NOTICE TO ALL BIDDERS

**ADDENDUM NO. 2
TO
TUCSON AIRPORT AUTHORITY
TUCSON INTERNATIONAL AIRPORT
10219007 CBP RELOCATION**

January 23, 2019

ARCHITECTURAL SITE PLAN
SCALE: 1" = 20'-0"

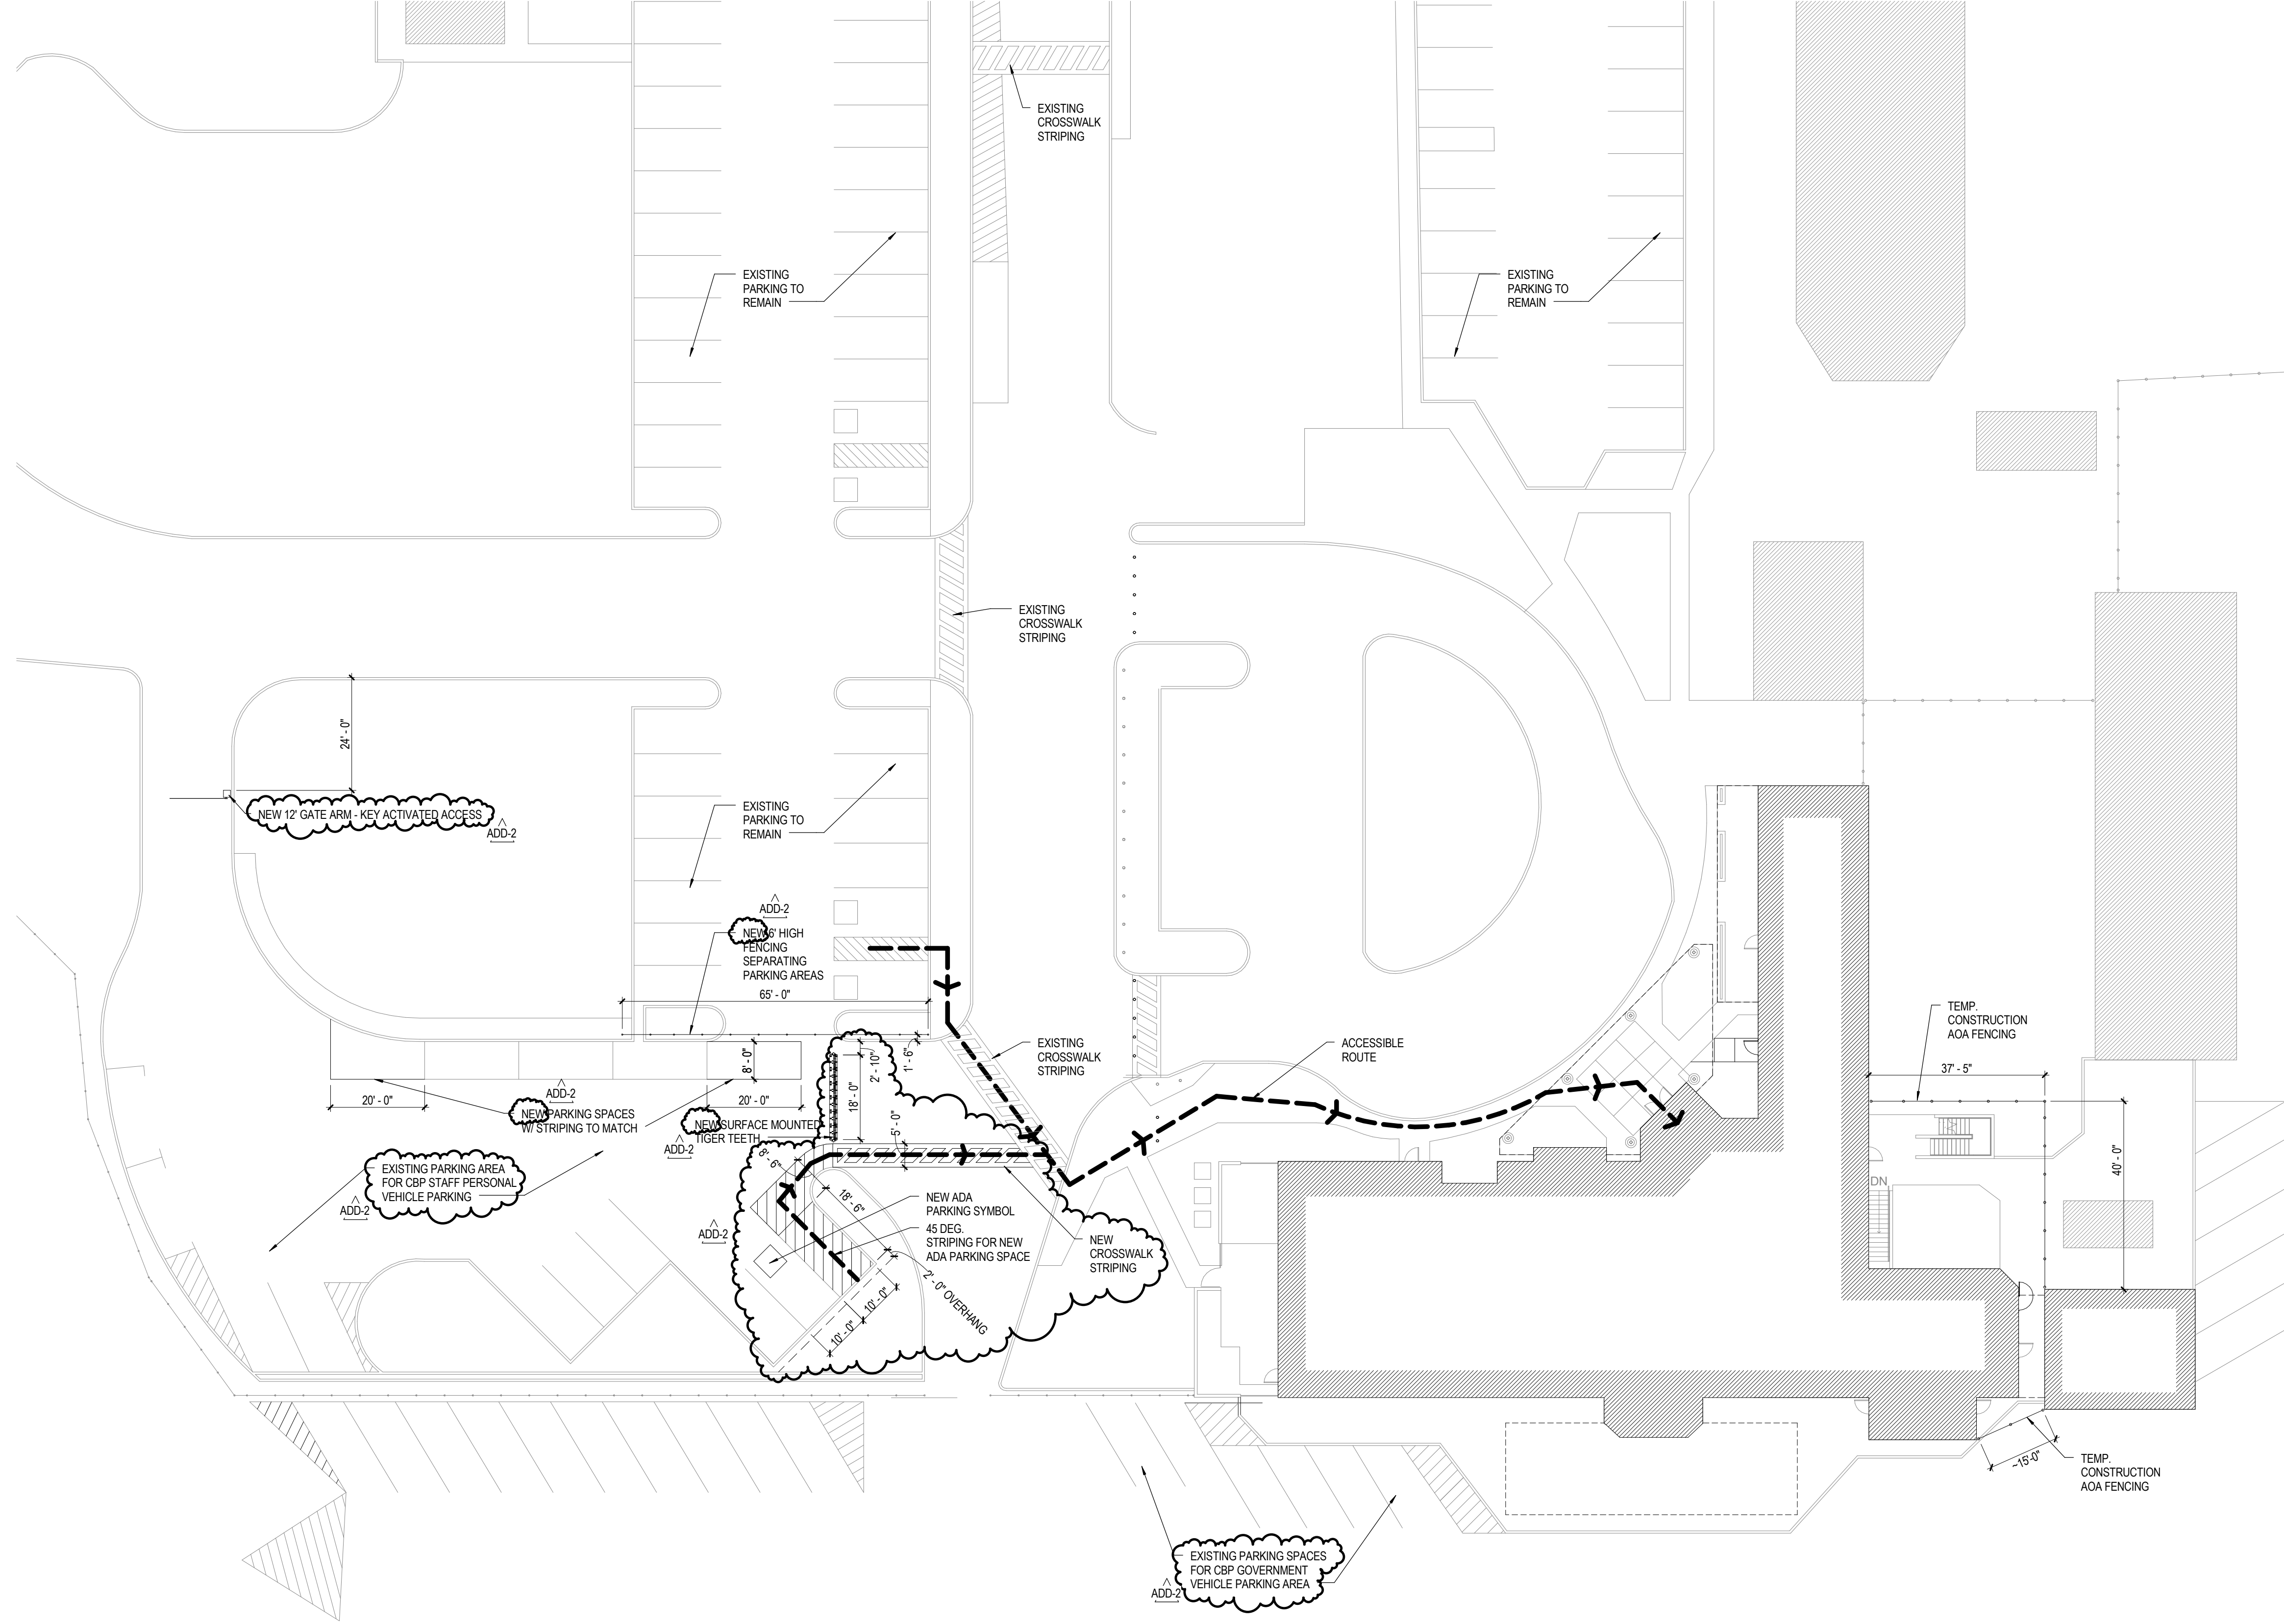
On sheet AS1.1, items are labeled as 'new' and 'existing', and other items are not labeled as such. Please clarify which items are to be included in the scope of work. (i.e. 12' gate arm, tiger teeth, 6' high fence separating parking areas)

- A. Modify drawing per attachment AS1.1 of Bid Addendum #02 dated January 23rd, 2019
- Clarifications added to notes delineating new from existing site improvements.
 - Reduction of traffic spike quantity and new layout of ADA parking and striping in CBP staff parking.

Response: We will clarify the notes for all new and existing items.

FLOOR PLAN - FURNITURE
TAA Executive Terminal
CBP Relocation TAA project #10219007

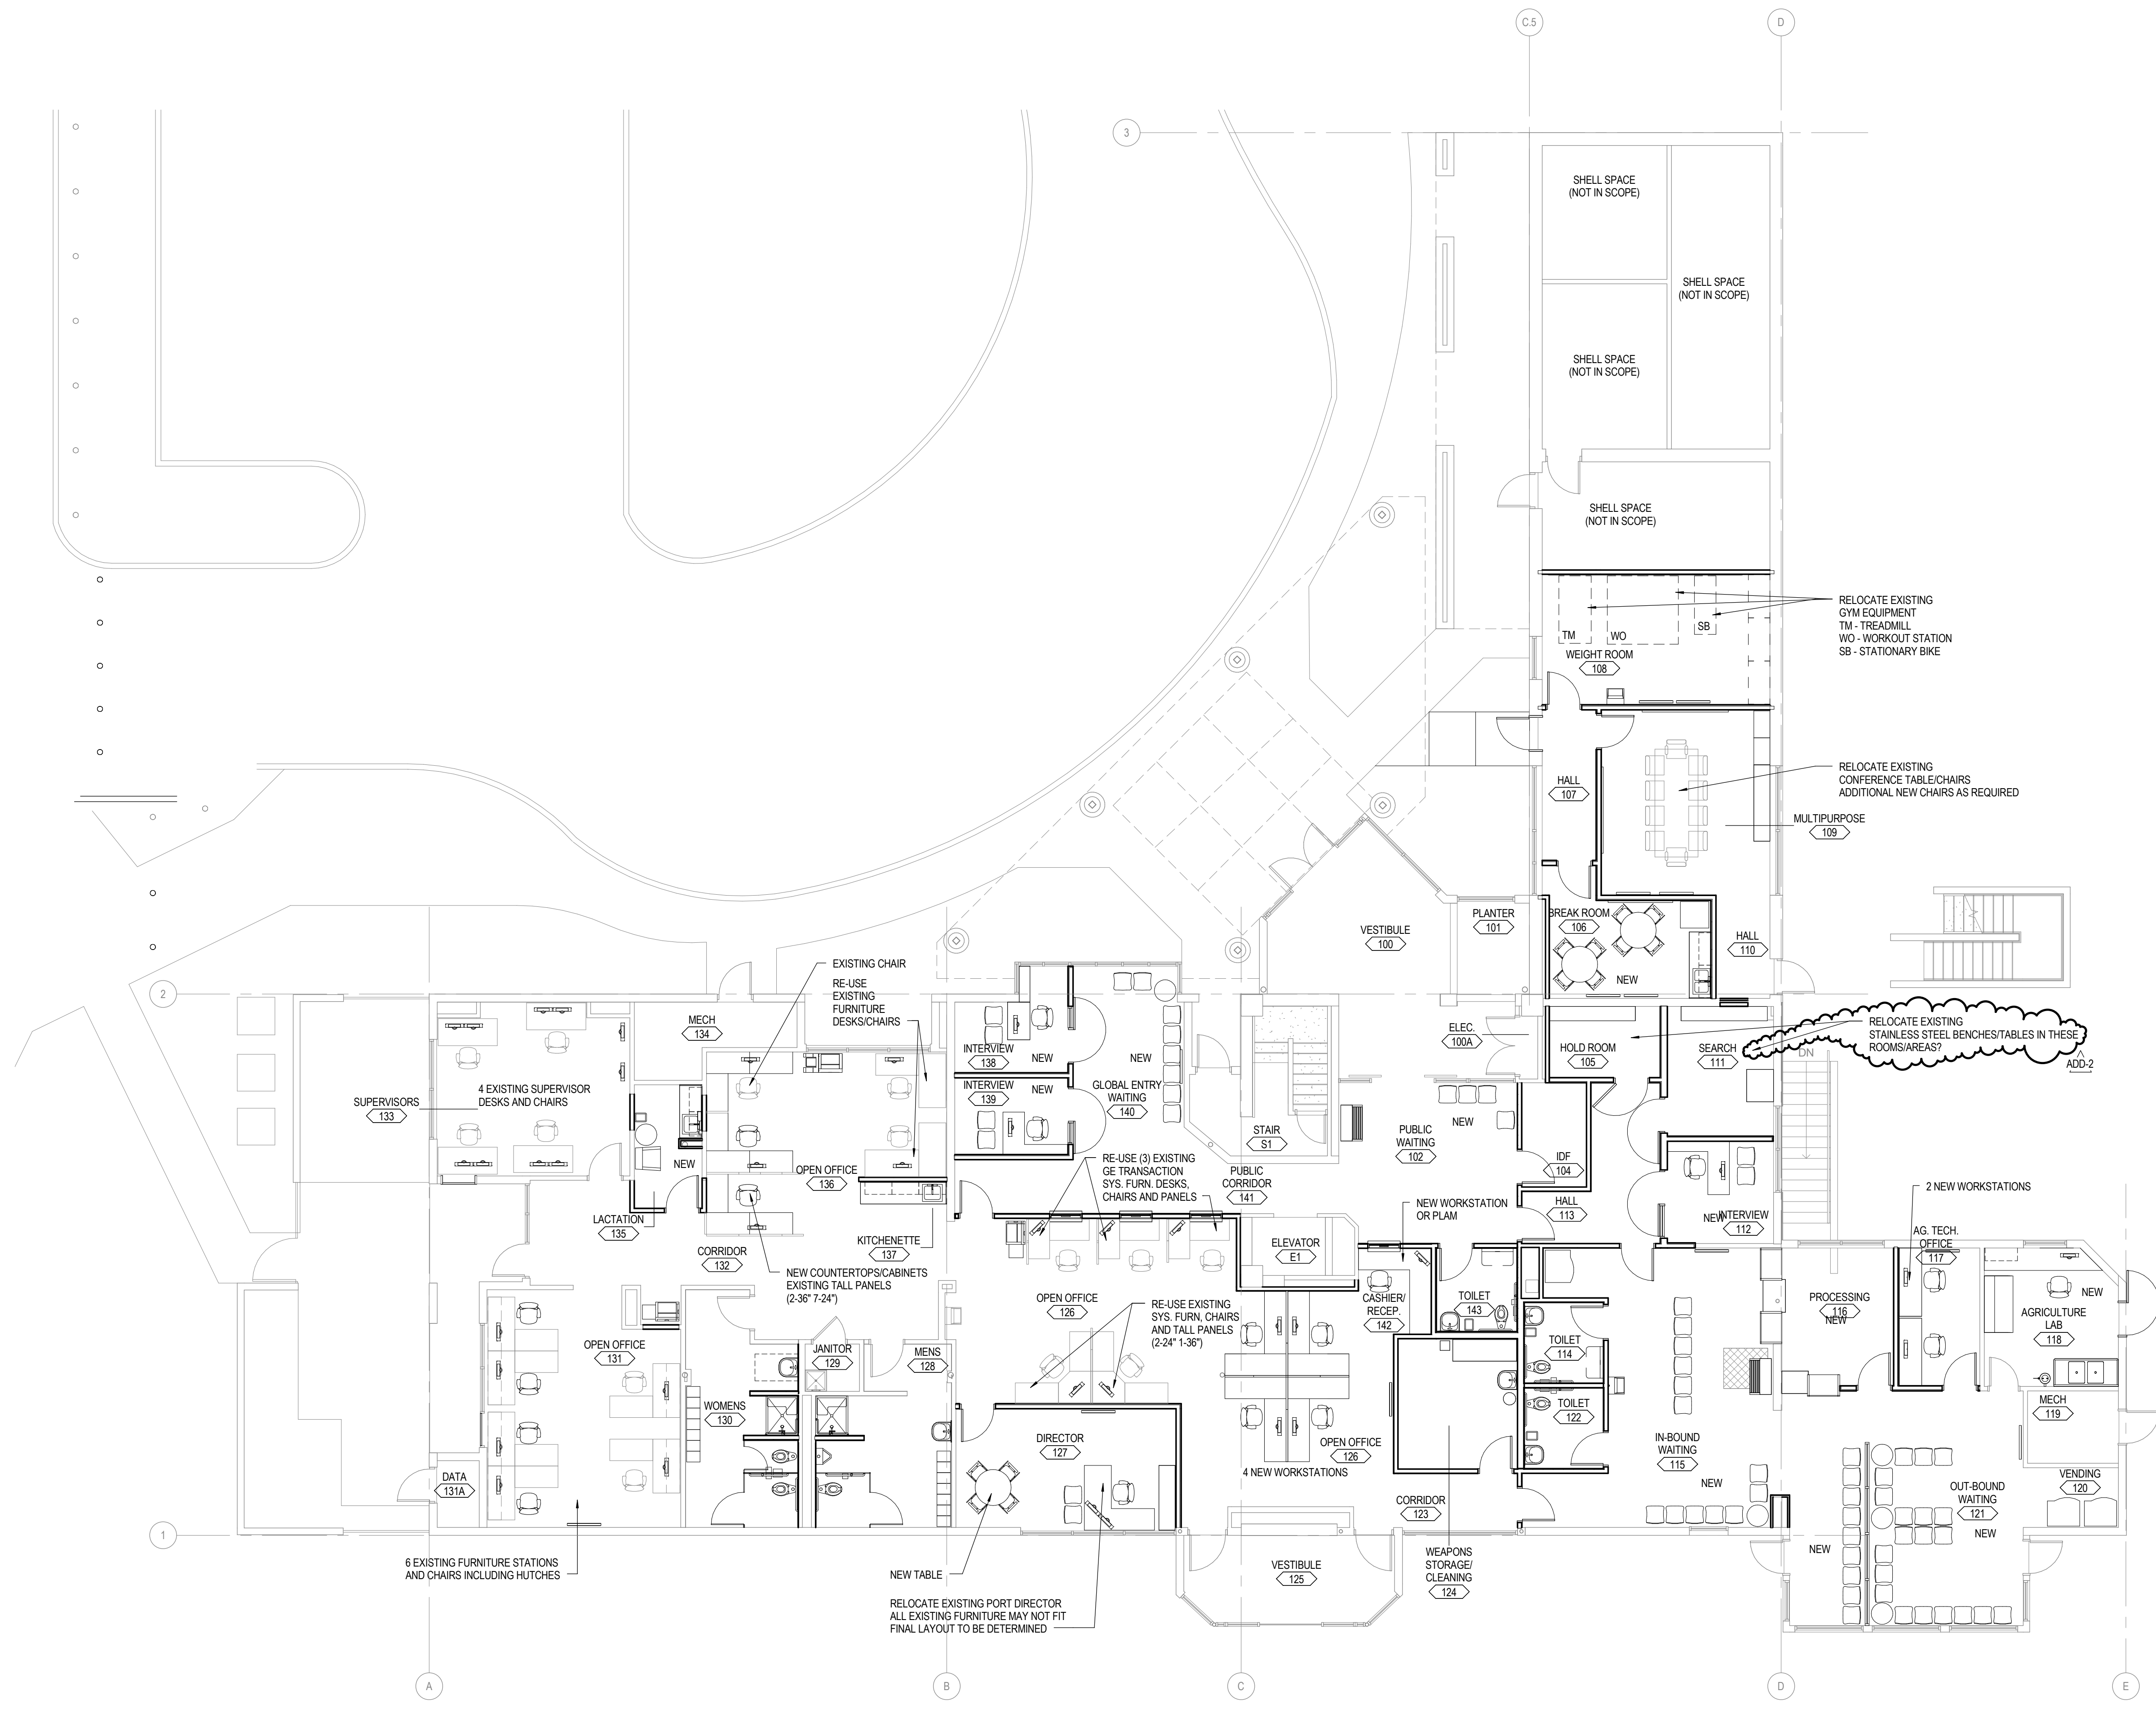
On sheet A1.4, are all items shown by Owner? Is the GC responsible for any scope of work shown on this sheet.

- A. Modify drawing per attachment A1.4 of Bid Addendum #02 dated January 23rd, 2019
- Note modified for stainless steel benches and tables to reflect relocation of existing.

Response: All furniture to be OFOI. The only GC scope is the stainless benches and tables in the hold room and search room. Please refer to question 4 for additional information. Note will be revised on sheet to reflect relocating the benches and table.
